# PENNDOT e-Notification

## BRADD

No. 015

## Problem with Deck Transverse Reinforcement

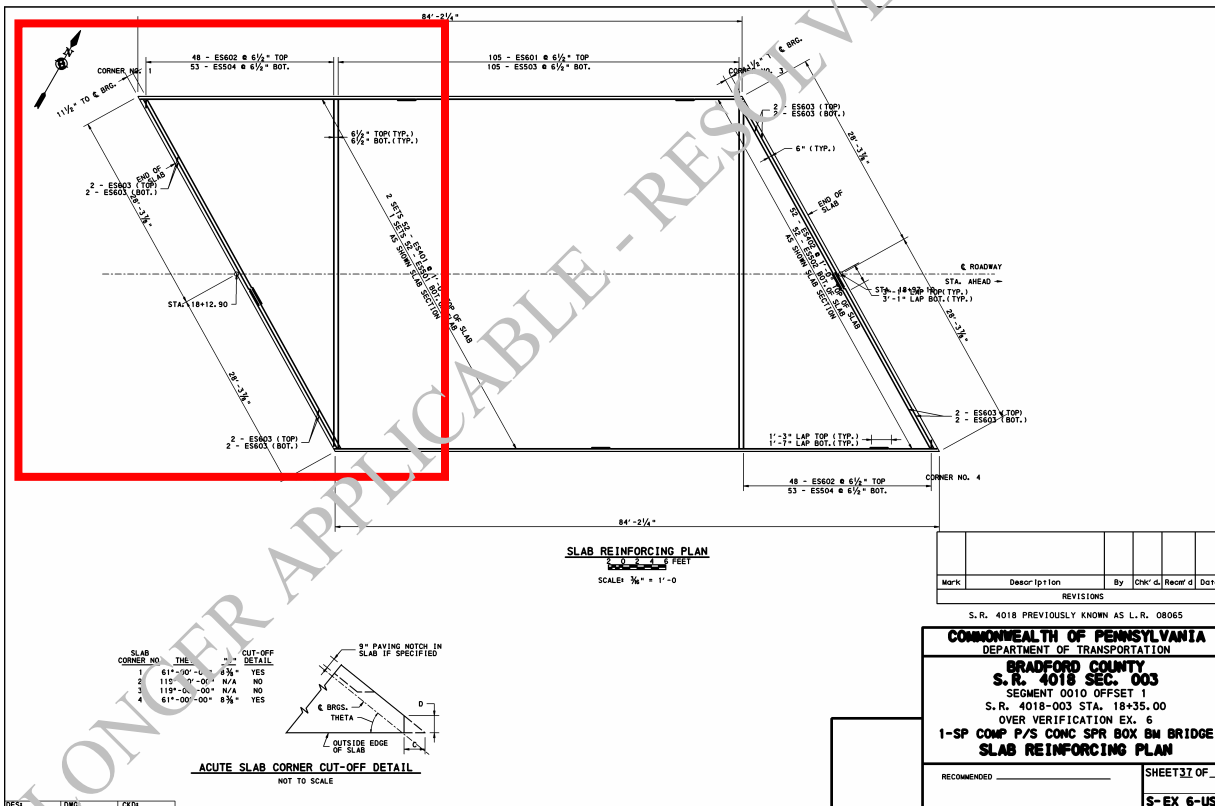
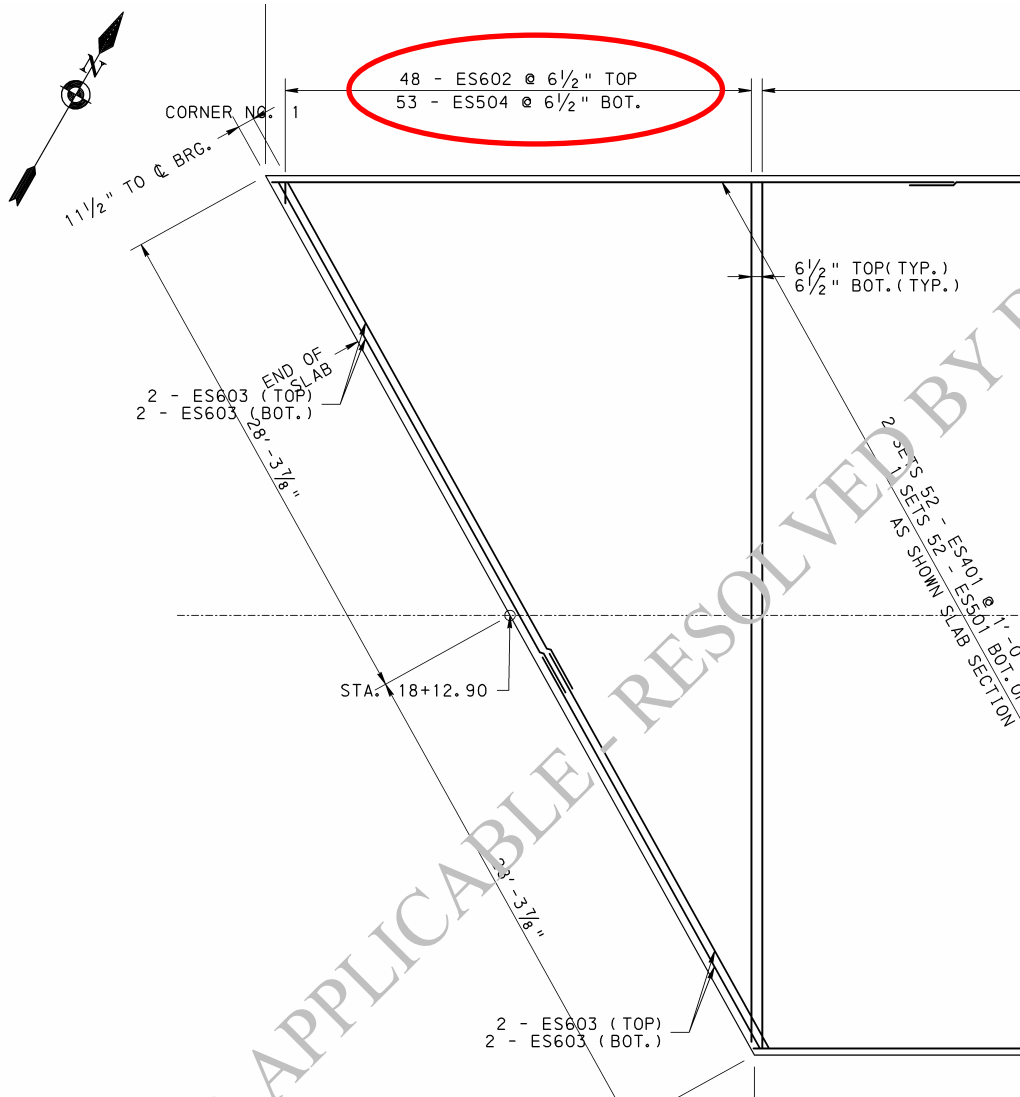
BRADD has an error when calculating the number of and the lengths of the rebars required in the acute corners of the slab reinforcing plan for spread beam superstructures. This problem only occurs for tangent decks with a skew angle less than 75 degrees. An example slab reinforcing plan demonstrating this problem is shown below, followed by a close-up of the corner at abutment 1.

The rebar labeled "ES504" in the above detail has the number of rebars computed incorrectly. The number should match that of the top bars (48) which are computed correctly. For this example, the spacing of the top and bottom bars is the same. Regardless of whether the spacings are the same or different, the user will need to recalculate the number of bottom bars and their lengths, and then change the reinforcement bar chart accordingly. These same bars are also placed in the other acute corner of the slab reinforcing plan at abutment 2.

- Recalculate and modify the number of bottom slab bars in the acute corners of the slab and modify both the slab plan and superstructure reinforcement schedule.
- Recalculate and modify the length of the top slab bars in the acute corners of the slab and modify the length shown in the superstructure reinforcement schedule.
- Recalculate the total reinforcement computed by BRADD based on the above two calculations.
